MOST- Alternative Gallery,  
Level 7-12A,  
Jockey Club Creative Arts Center (JCCAC),  
30 Pak Tin St.,  
Shek Kip Mei,  
Kowloon,

**Re:** Submission of Museum of Site|| MOST to Legco dated Sep 7, 2009 (2:30 pm)

## **Appendix: APPRAISAL ON JCCAC'S GALLERY DEFECTS & WIDER CONSIDERATIONS**

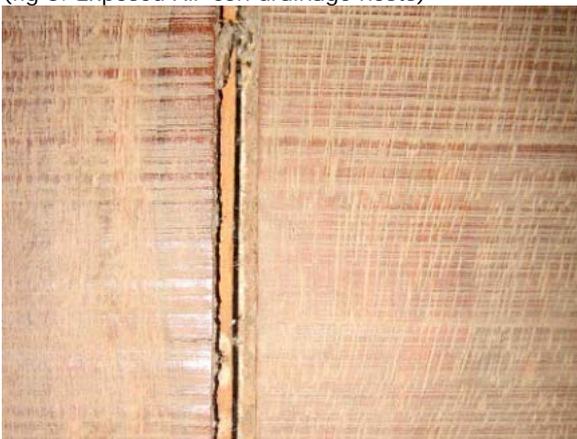
- 8.3. **INAPPROPRIATE USE OF 'REFLECTIVE' MATERIALS IN GALLERIES**
- 8.3.1. **Silver-colored pipes, grey drainage hosts** in the galleries (fig. 1) should be re-painted in matt white color. Some lines should be re-positioned/ re-routed or white box-covered (fig. 2; fig. 6) to minimize its shimmering effects as well as for safety reason.

- 8.3.3. The current wooden floor paneling is not easy for reversion and some **ground-up installations using sand, water ... are impossible**.
- 8.3.4. **Matt coating** on the surface of floor planks should be made to protect the robust, materials. Currently it is coated on single/ back side only and the **shrinking effect** in cool times is increasing, making connecting lines/ cracks separate, wider and the **floors uneven** (fig. 3), particularly hard for wheelchair users.

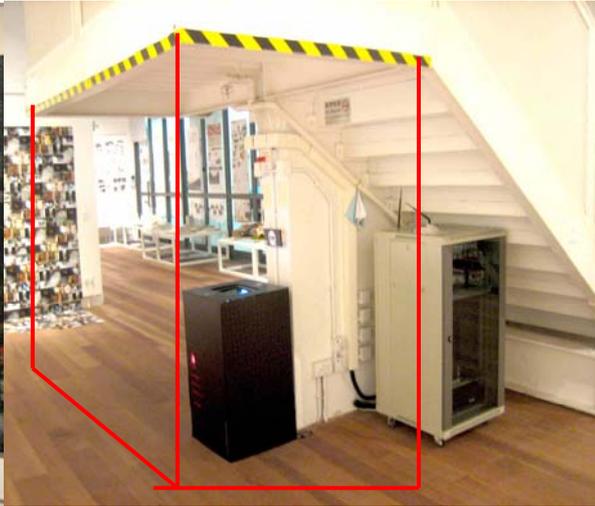
- 8.2.5. The 20-ft H gallery on G/F or 0/F is currently mounted with **low-level 8' or 2,440mm high, railed wooden boards** (fig 7), which means hanging of 2-D works higher than 8' (i.e. 9-feet, 10-foot paintings) will become impracticable as the railings will interrupt the flat level of hanging.

- 8.3.5. All **unplugged sockets** should be covered with white plastic caps to ensure gallery safety (fig.4) and all **messy electricity lines** in the galleries must be ordered with white plastic wire cover (fig. 5).

- 8.4. **LIGHTING**
- 8.4.1. **Poor architectural design and gallery lighting design** is causing viewing problem. **The use of horizontal, door-windows** (fig. 6) framing outside views with white curtains/ blinds modeled on Mies's Glass House prototype is a wrong design. Big door-window lighting/ side-lighting should not be located in major gallery spaces, but in circulation spaces between galleries only (i.e. a good example is The Pao Gallery on the 5/F of The Hong Kong Art Centre) because of the natural occurrence of **phototropic effect**, which can make the eyes of audiences automatically attended to the brightest object (i.e. glasswork) in their fields of view. **Glare effect** make adaptation of the eyes to the low light levels constantly inhibited.
